Meeting Agenda

Franklin Municipal Planning Commission

Thursday, February 23, 2017

**SIMMONS RIDGE PUD SUBDIVISION, DEVELOPMENT PLAN
REVISION 4
FRANKLIN MUNICIPAL PLANNING COMMISSION
3/23/2017**

C5.0
COF #6339

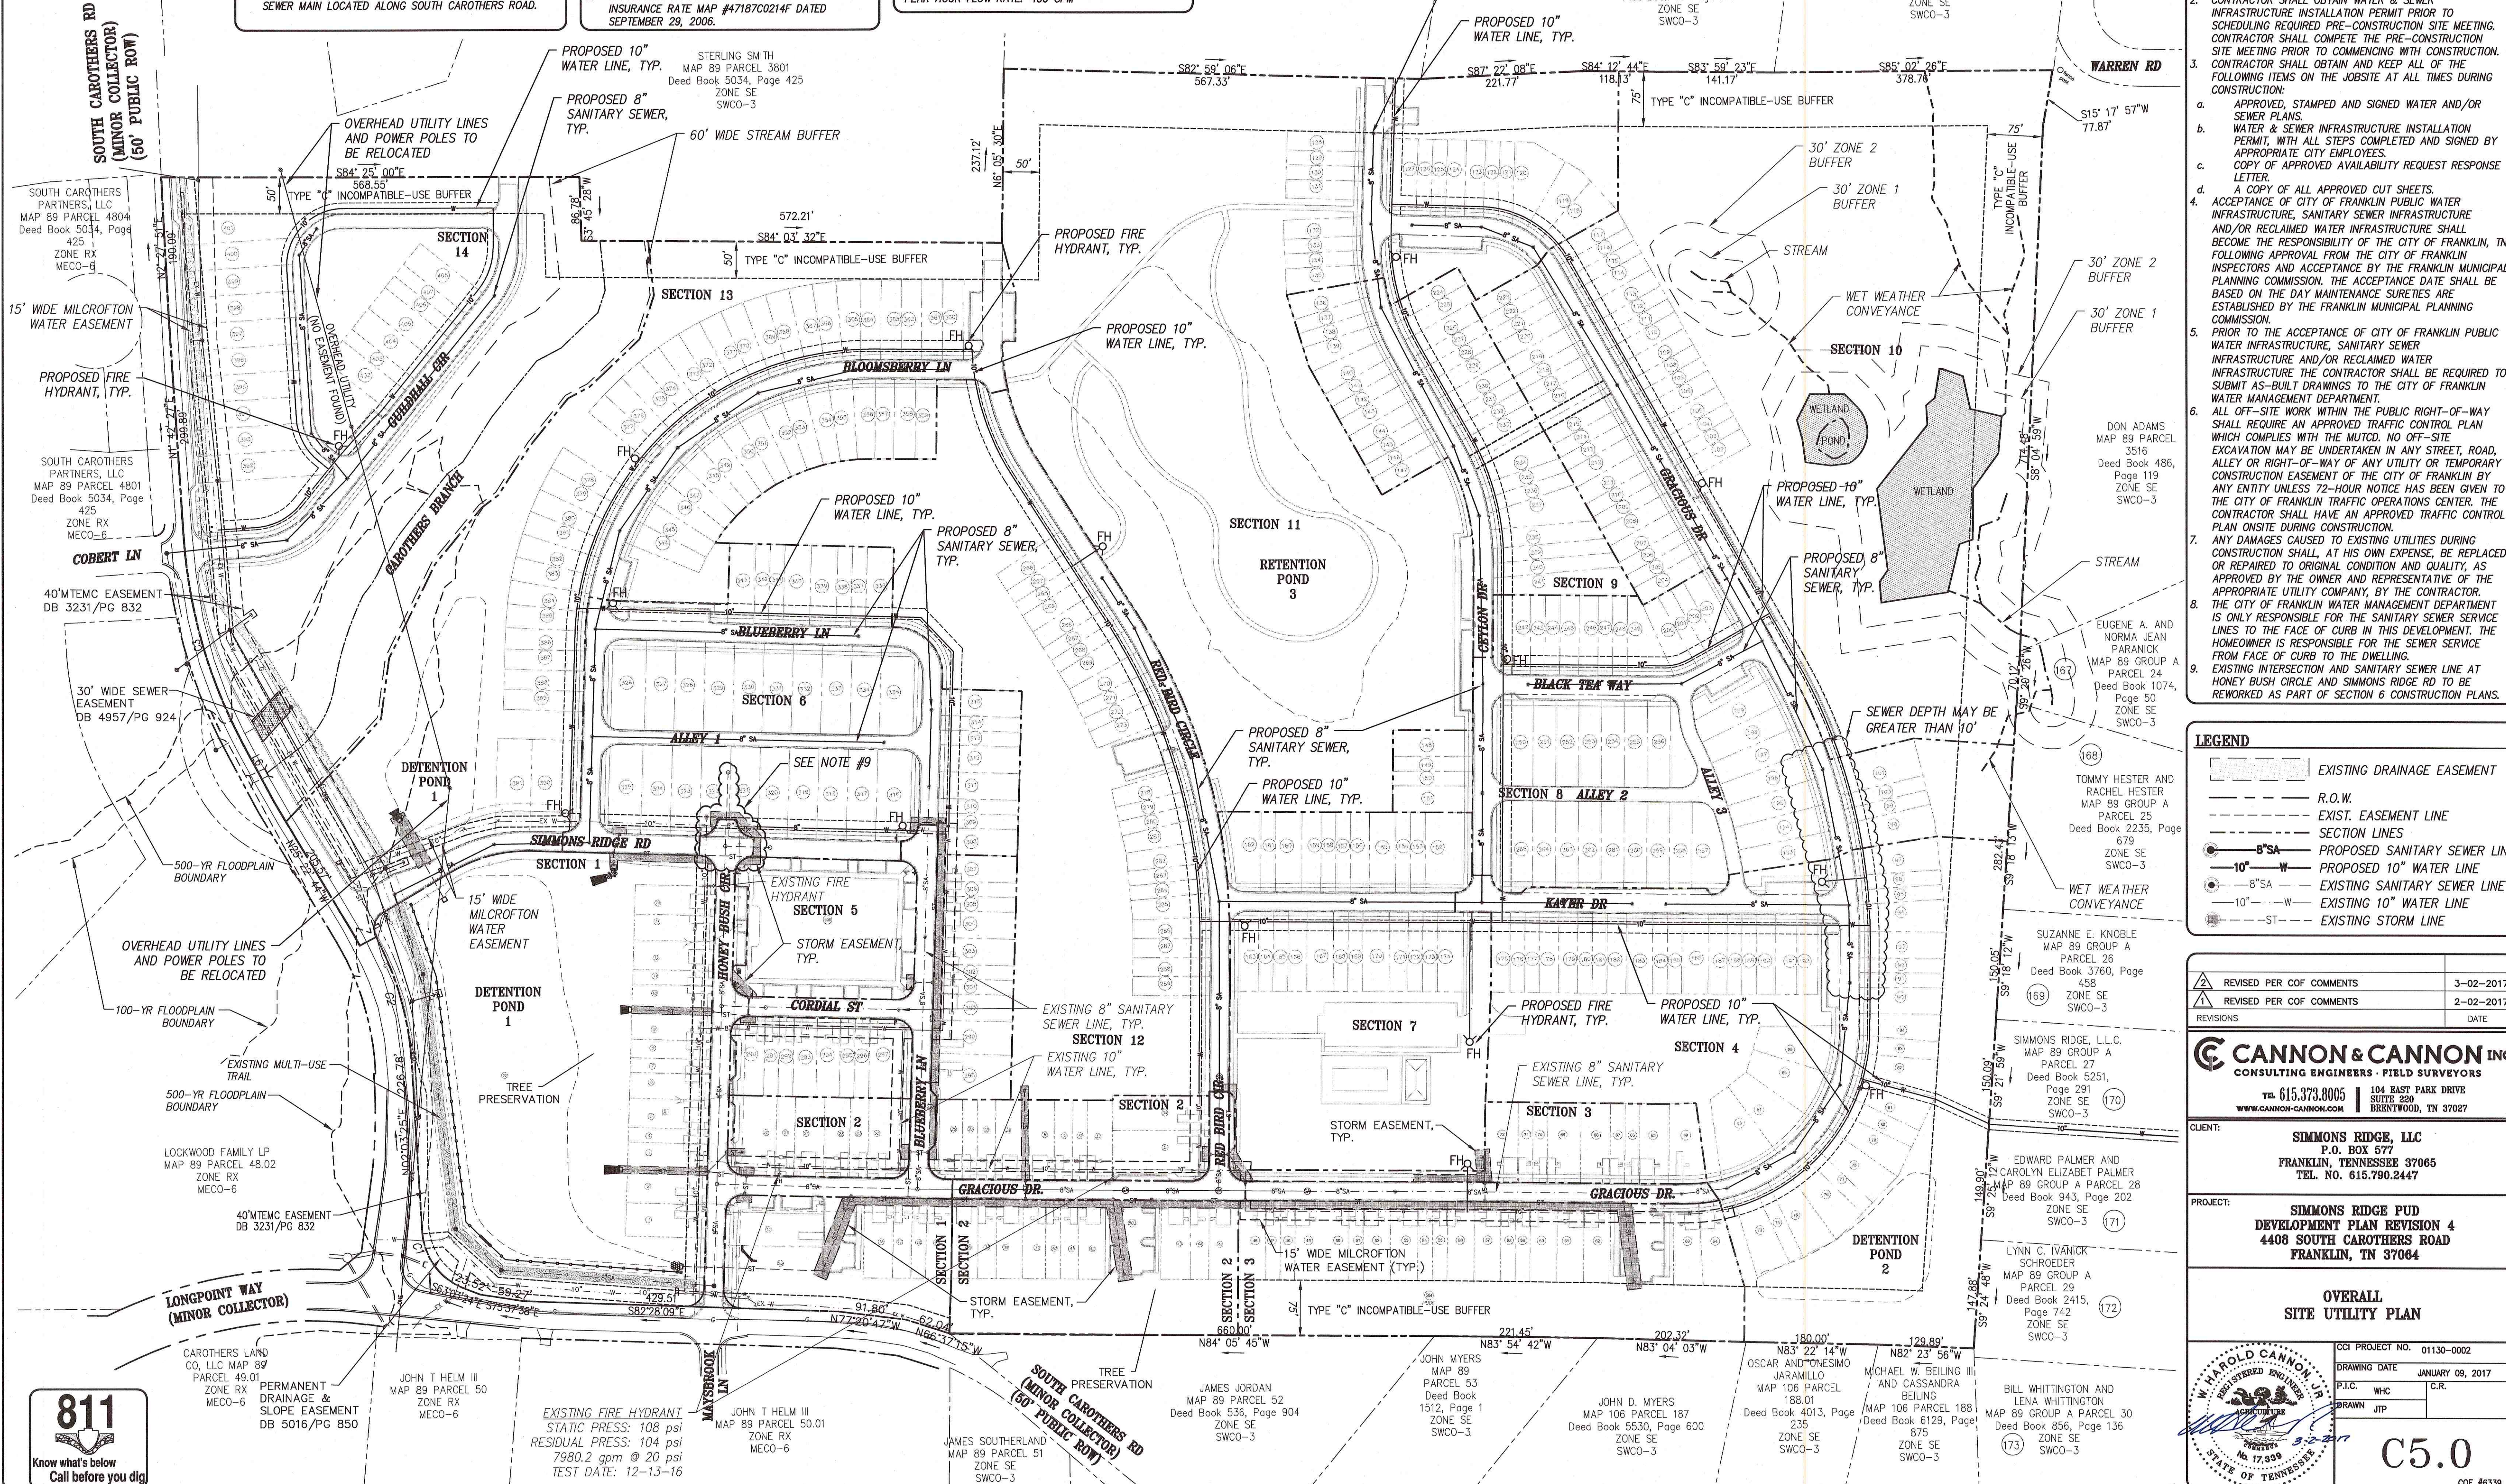
jimmy.wiseman@franklin.tn.gov Per the meeting with Engineering on 02/09/2017, the applicant shall provide a note that addresses offsite roadway improvements south of the development. Coordination with Staff prior to One-Stop is required.

jimmy.wiseman@franklin.tn.gov Per the meeting with Engineering on 02/09/2017, the applicant shall provide a note that addresses offsite roadway improvements south of the development. Coordination with Staff prior to One-Stop is required.

joe.marlo@franklin.tn.gov Applicant shall provide adequate lighting at intersections and at on-street parking locations, or verify that existing lighting provides illumination meeting COF Standards at these locations. This item is to be addressed at the Site Plan stage.

25. HVAC

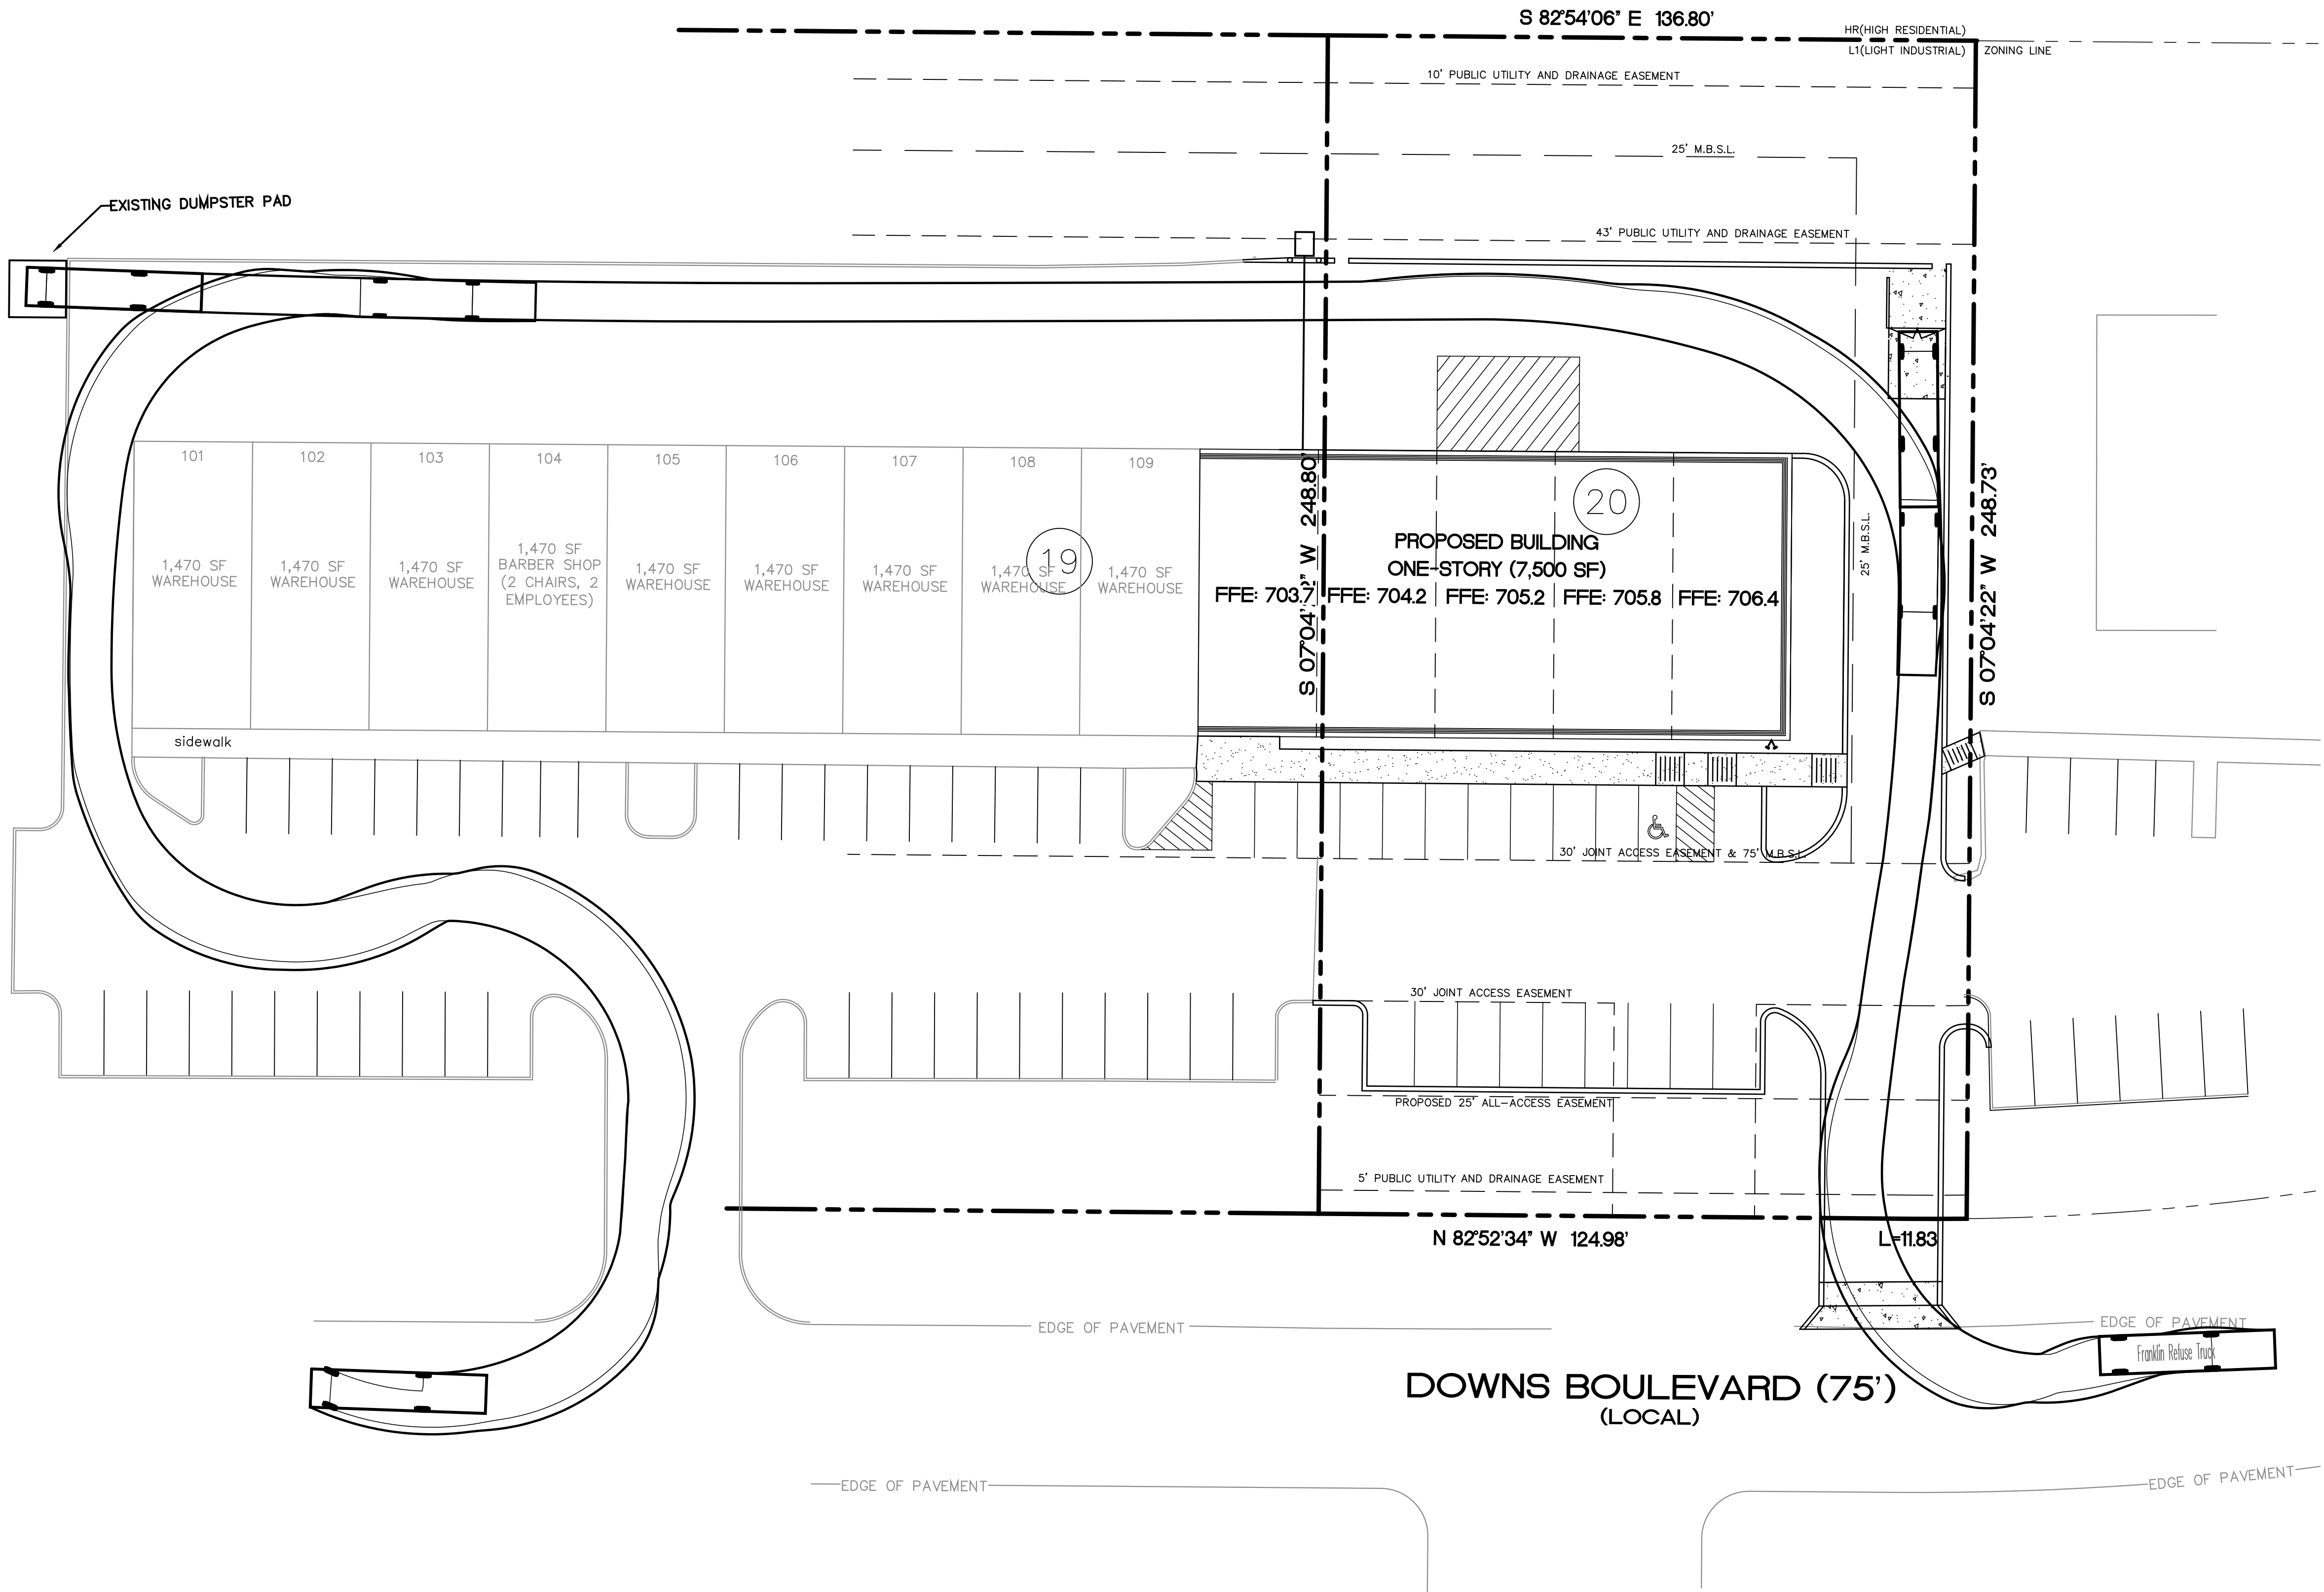
shanna.mccoy@franklintn.gov Please specify location of note. Note not found.
